Re: King I Mine, C-1981-035

Stoner Engineering: Quarterly Inspection: Water Quality Improvements

Re: King Coal I – Quarterly Water Quality Improvements Inspection

Pic. 1 – West pond.

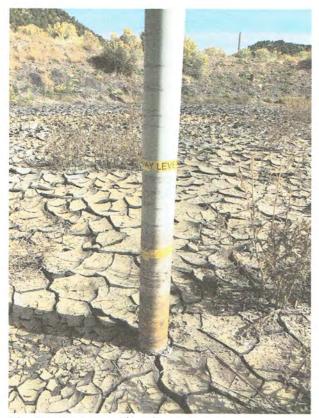
Both ponds were dry at the time of the inspection and appeared to generally be in good condition (see Pic. 1). The sedimentation gages show the ponds are not yet it need of cleaning (see Pic. 2). The western pond saw an increase in the sediment loading during a storm event since the previous inspection. An additional storm event or two of similar intensity will likely require the sediment pond to have the built-up sediment removed in order to continue to function as originally designed. Consideration for removal of the excess material with dry conditions may warrant performing the work this fall rather than the wetter spring or early summer seasons when the site conditions may become much wetter and more difficult to complete. The ponds should continue to be monitored after storm events to ensure that excess sediment does not reduce the required storage capacity available for storm water runoff.

Pic. 3 – Sediment trap at driveway.

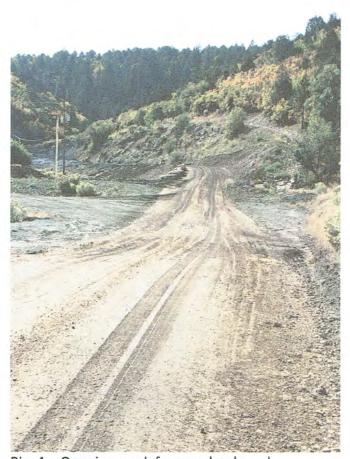
The sedimentation traps at the entrance to the site are generally in good condition but need some cleaning (see Pic. 3). Work is ongoing for the new haul road along the west side of the property (see Pic. 4). Waste material continues to be placed at the base of the embankment and moved via loader to the top of the pile. The culvert located at the top of the waste embankment pile under the haul road has been partially crushed at its upstream end and should be repaired (see Pic. 5).

Pic. 6 – North clear water ditch relocation (lower section).

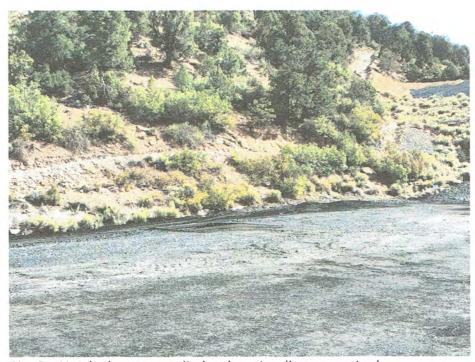
The lower section of the north clear water channel has been reconstructed near the base of the waste embankment pile (below the improvements constructed last year) (see Pic. 6). The relocated channel is now higher on the slope below the disturbance limits. The existing culverts throughout the site were in good condition at the time of the inspection.
